Access Compliance Report

Public Rights-of-Way

(Curb Ramps)

Intersection ID: 48858	Main Street: SHALLOW_WELL_DR	Cross Street: FENCELINE_DR	Location:	NW
ADA ID: 4F685C2E7A48	Ramp Type: BlendTrans2	Initial Pass/Fail: Fail	Overall Compliance: No	Severity Score: 12.5
Codes/Mitigation Info/Possible Solution		Field Measurements/Component Compliance

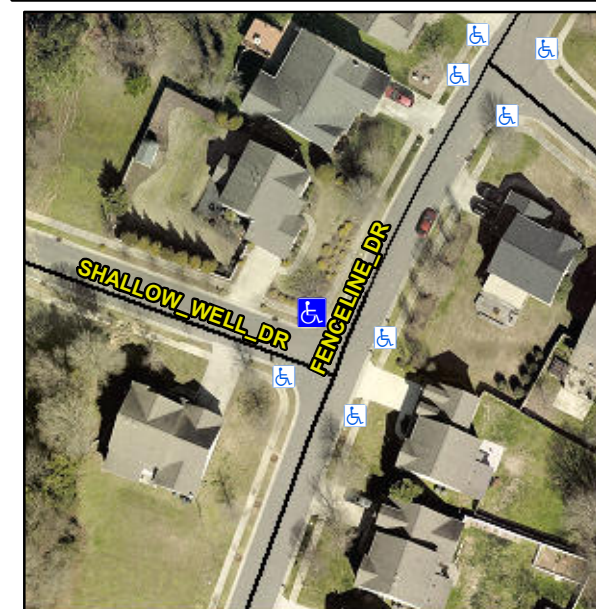
R304.5.3

Compliance	Description	Data	Compliance	Description	Data
N/A	Ramp Length (in)	45.0	Yes	BlendTrans Slope (%)	4.8
Yes	Ramp Width (in)	48.0	No	BlendTrans XSlope (%)	5.4
N/A	Flare Type LT	N/A	N/A	Flare Type RT	N/A
N/A	Flare Slope LT (%)	N/A	N/A	Flare Slope RT (%)	N/A
N/A	Flare Traversable LT?	N/A	N/A	Flare Traversable RT?	N/A
N/A	Landing Length (in)	N/A	N/A	DWS Provided?	N/A
N/A	Landing Width (in)	N/A	N/A	DWS Contrast?	N/A
N/A	Landing Slope (%)	N/A	N/A	DWS Length (in)	N/A
N/A	Landing X Slope (%)	N/A	N/A	DWS Full Width?	N/A
N/A	Landing Curb? (Y/N)	N/A	N/A	DWS Offset (in)	N/A
N/A	Shared Landing?	N/A			
N/A	Gutter Ponding?	N/A	N/A	Gutter Slope (%)	N/A
N/A	Gutter Lip Ht (in)	N/A	N/A	Gutter X Slope (%)	N/A
N/A	Painted X Walk1?	No	N/A	Painted X Walk2?	No
	X Walk 1 Direction	To SW		X Walk 2 Direction	To SE
	X Walk 1 Width (in)	N/A		X Walk 2 Width (in)	N/A
	X Walk 1 Slope (%)	2.7		X Walk 2 Slope (%)	5.6
	X Walk 1 X Slope (%)	4.0		X Walk 2 X Slope (%)	0.9

Remove & Replace Curb Ramp With Two New Directional Ramps or Equivalent.
